UNITED STATES PATENT AND TRADEMARK OFFICE

APPLICATION NO.	FILING DATE	FIRST NAMED INVENTOR	ATTORNEY DOCKET NO.	CONFIRMATION NO.
10/608,671	06/27/2003	Michael J. Pugia	MSA-3452	5201

Office Action Summary

DETAILED ACTION***Election/Restrictions***

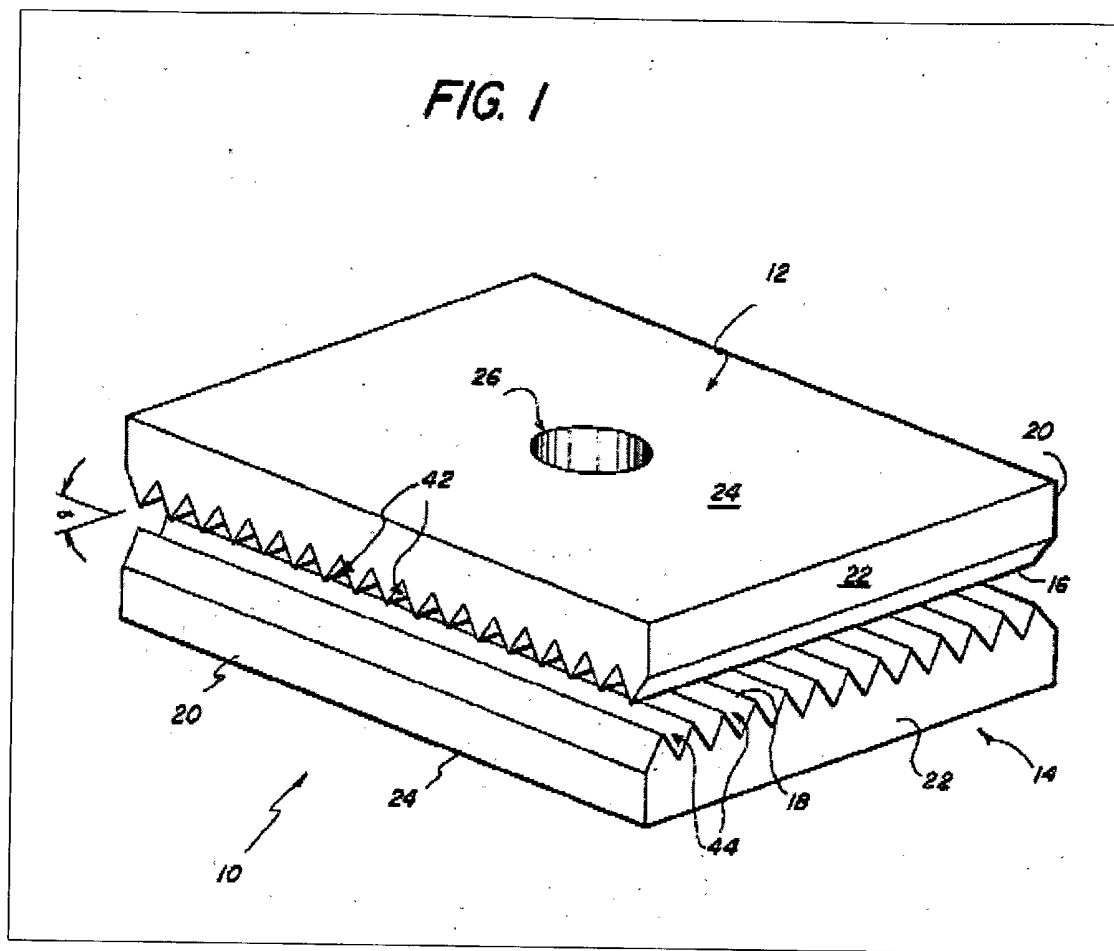
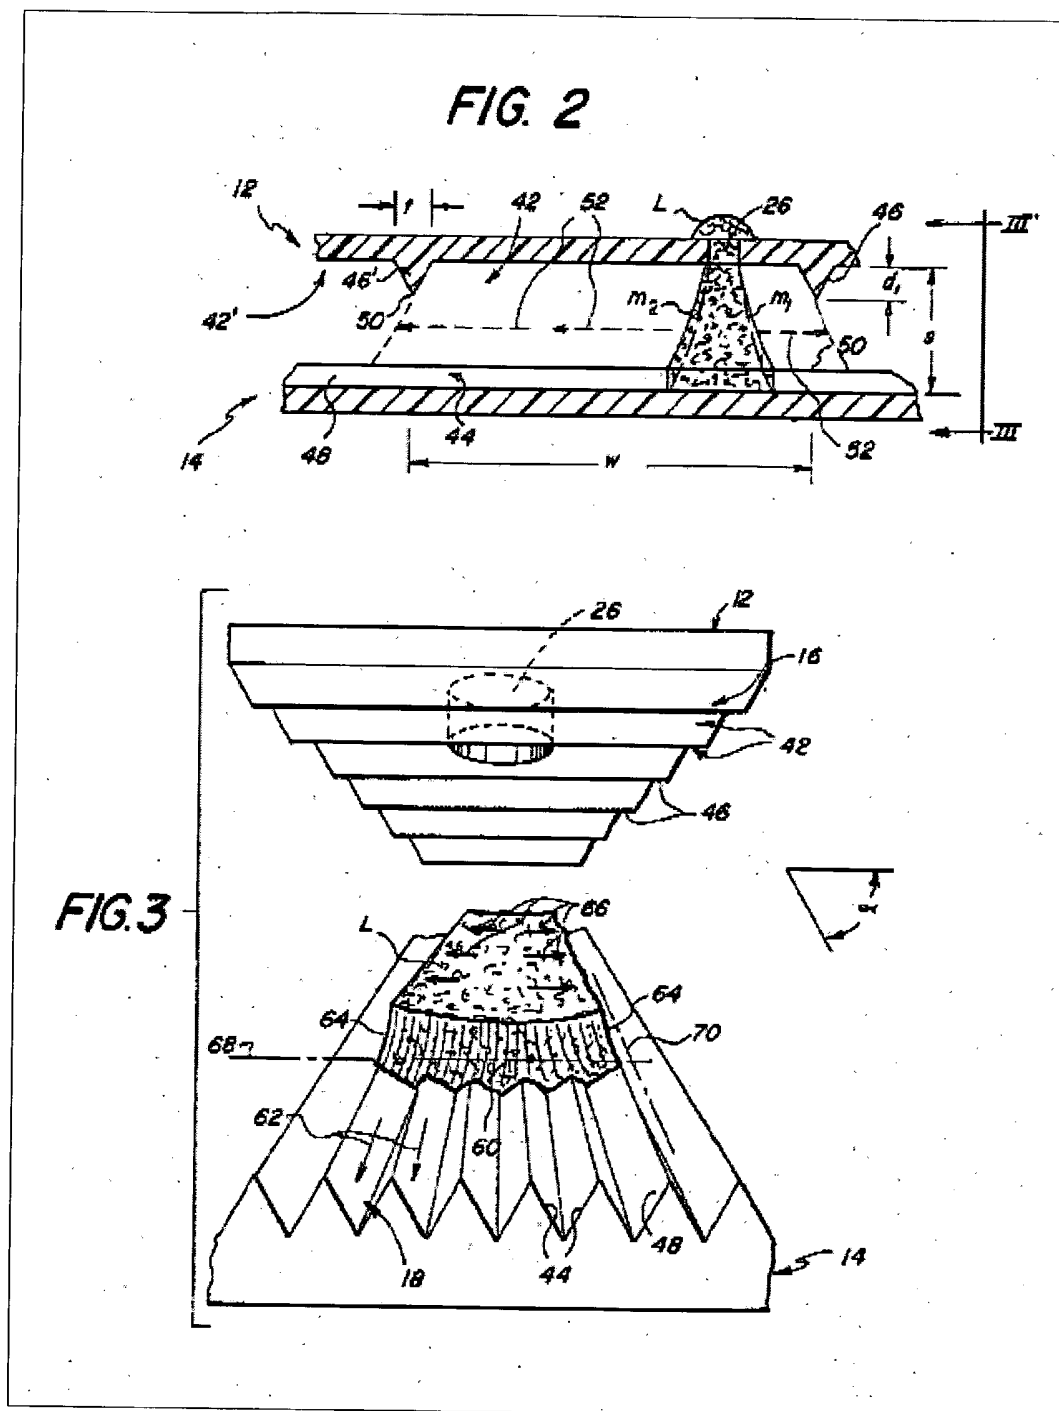
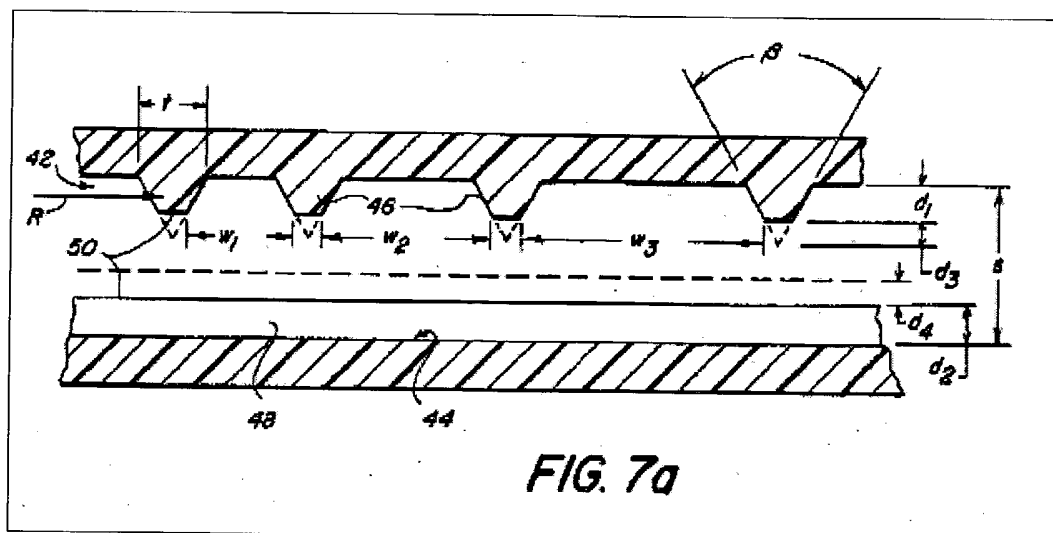
1. Claims 1 – 3 and 8 are rejected under 35 U.S.C. 102(b) as being anticipated by Columbus (U.S. Pat. No. 4,233,029). Regarding claims 1 and 2, Columbus '029 teaches a microfluidic apparatus (10) comprising: an inlet port (aperture 26); a capillary passageway (e.g., the sidewalls of the inlet port 26 extending through top member 12) in fluid communication with the inlet port (26); an inlet chamber (e.g., the spacing between interior surfaces 16 & 18) in fluid communication with the capillary passageway, wherein the inlet chamber comprises means (grooves 42 & 44) for uniformly distributing sample fluid across the chamber and displacing air from the chamber; and at least one vent passageway (e.g., the space between members 12 & 14 left exposed at either edge 20 or 22) (see col. 1, line 1 – col. 6, line 60; figures 1 – 3).

Regarding claim 3, as shown in figure 7a, Columbus '029 further teaches the incorporation of weir structures (truncated ridges 46) within the apparatus (see col. 8, lines 1 – 51).

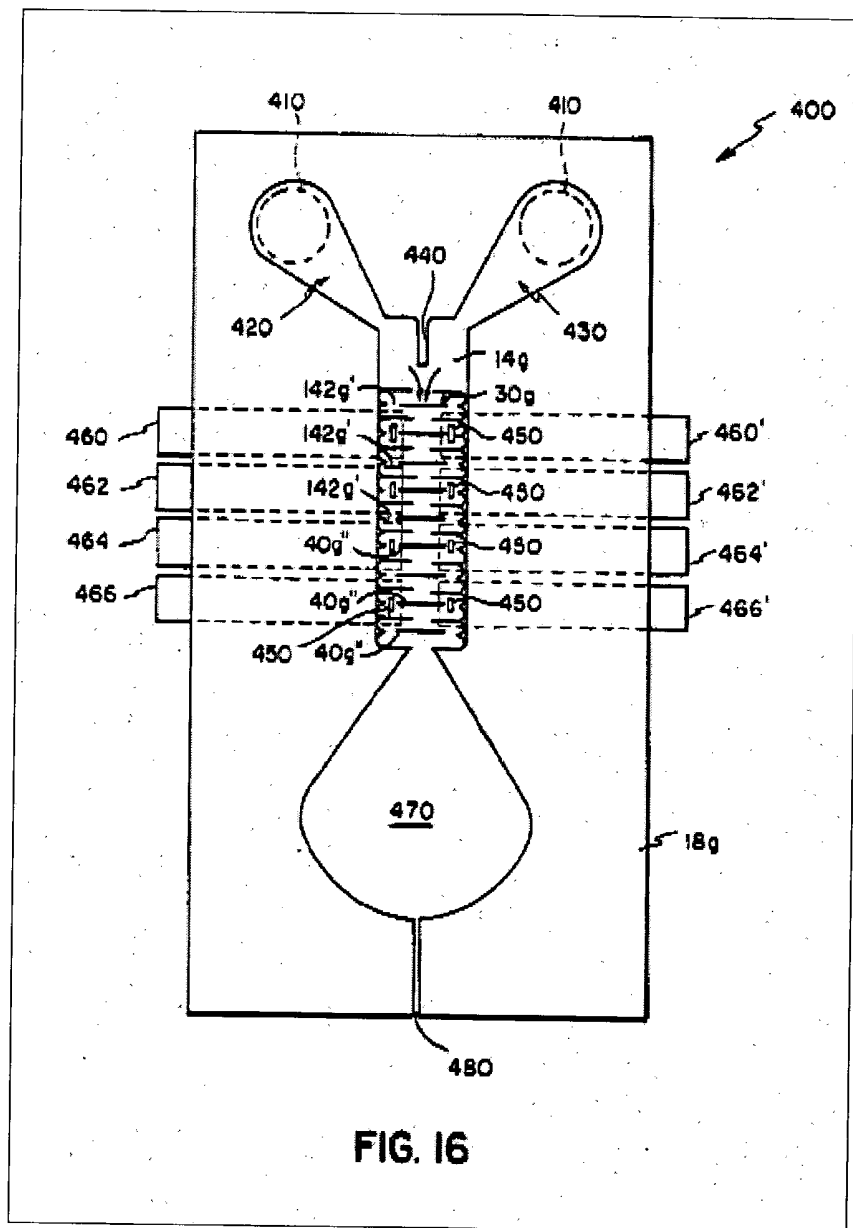
2. Claims 1 – 3 and 8 – 10 are rejected under 35 U.S.C. 102(b) as being anticipated by Columbus (U.S. Pat. No. 4,618,476). Regarding claims 1 and 3, as shown in figure 16, Columbus '476 teaches a microfluidic apparatus (multiple test element 400) comprising: an inlet port (inlet aperture 410); a capillary passageway (liquid delivery capillary zones 420 & 430) in fluid communication with the inlet port (410); an inlet chamber (capillary transport zone 30g) in fluid communication with the capillary passageway (420 & 430), wherein the inlet chamber comprises means (e.g., rib structures 40g", which are structurally equivalent to a weir structure) for uniformly distributing sample fluid across the chamber and displacing air from the chamber; and at least one vent passageway (vent aperture 480) (see col. 7, lines 15 – 64; figure 16). Regarding claim 2, Columbus '476 teach the incorporation of groove or slot structures (142g') within the apparatus.

Regarding claim 9, Columbus '476 teaches the incorporation of an overflow cavity or chamber (470) within the apparatus.

Fig. 3a

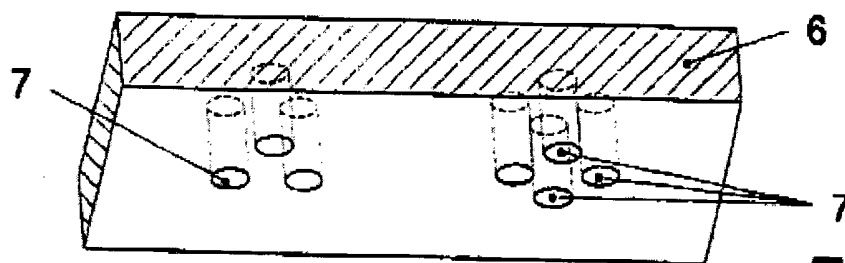
4. Considering objective evidence present in the application indicating obviousness or nonobviousness.
1. Claims 4 – 6 are rejected under 35 U.S.C. 103(a) as being unpatentable over Columbus '029 in view of Peters (U.S. Pat. No. 6,296,126 B1). Regarding claim 4, Columbus '029 is silent to the specific teaching of incorporating wedge-shaped cut-out structures with the microfluidic apparatus. As shown in figure 3b, Peters does teach the incorporation of wedge-shaped cut-out structures (columnar projection 9 having wedge-shaped cut-outs 1) within a microfluidic apparatus for facilitating effective fluid control within a microfluidic device (see col. 1, line 10 – col. 6, line 67; figures 1a, 3b & 4).

Fig. 3b

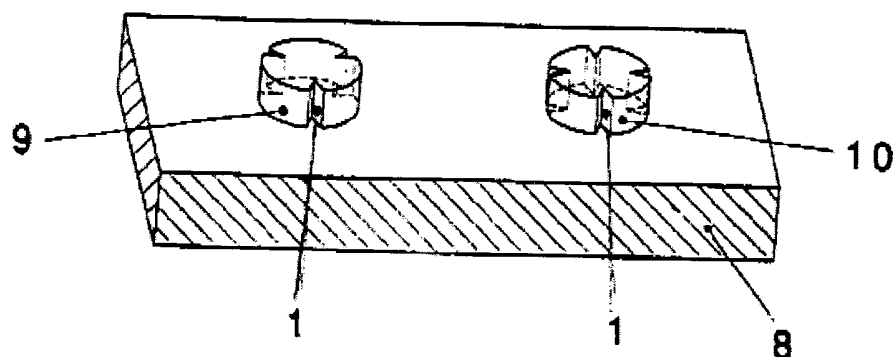
Regarding claims 5 and 6, as shown in figure 3b, these cylindrical or columnar projections (9) comprise essentially post structures, which extend from the base-plate (8), having wedge-shaped cut-outs (1) (see col. 5, lines 1 – 15).

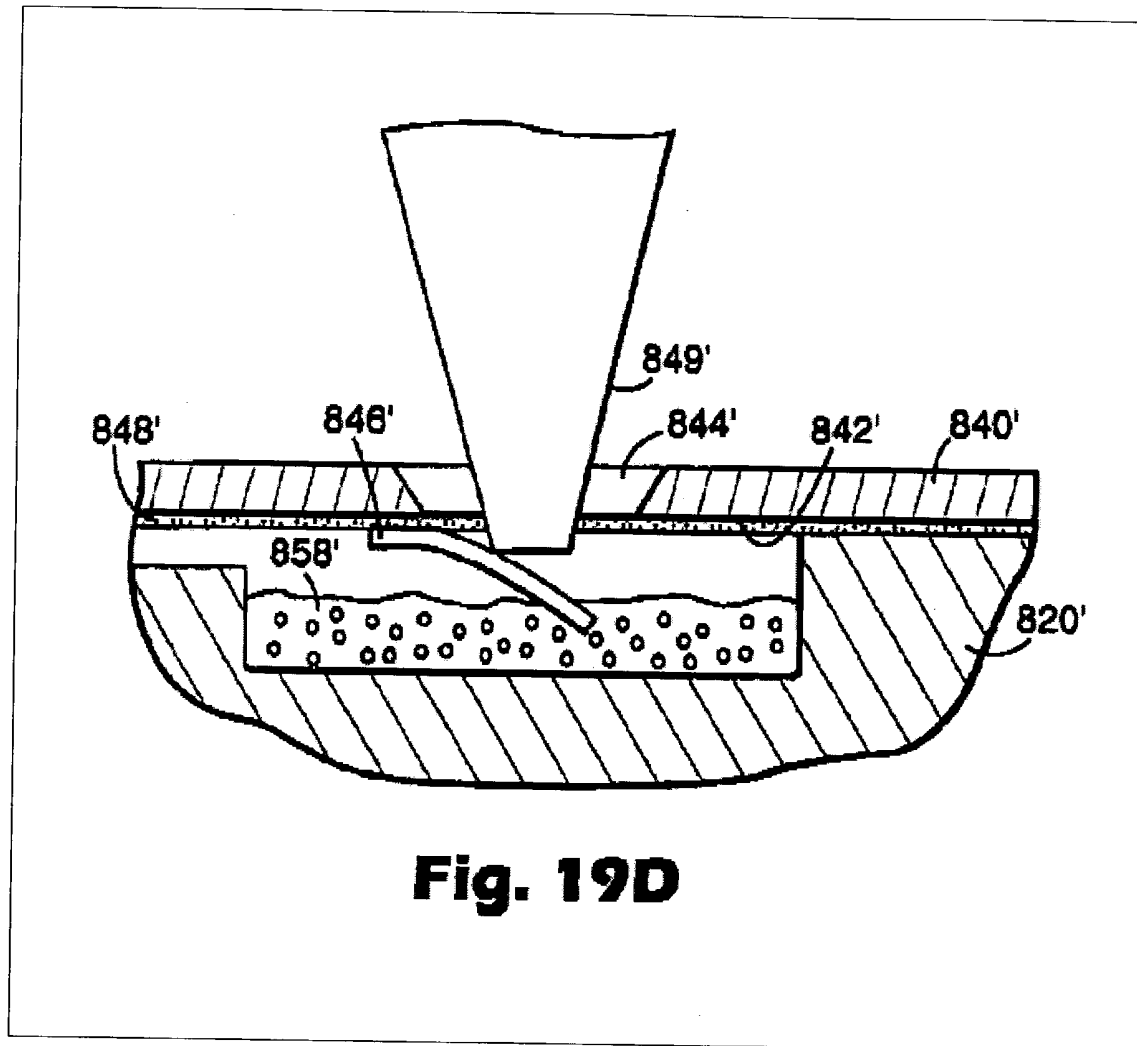
2. Claim 7 is rejected under 35 U.S.C. 103(a) as being unpatentable over Columbus '029 in view of Bedingham et al. (U.S. Pat. No. 6,734,401 B2). Columbus '029 is silent to the specific teaching of incorporating an inlet port that is tapered to engage the corresponding shape of a pipette tip for depositing a sample fluid into the apparatus. Bedingham et al. do teach the incorporation of an inlet port (844') that is tapered to facilitate engagement with the corresponding shape of a pipette probe tip (849') for

permitting the introduction of a sample fluid into the disclosed apparatus (see col. 32, lines 19 – 61; figure 19D).
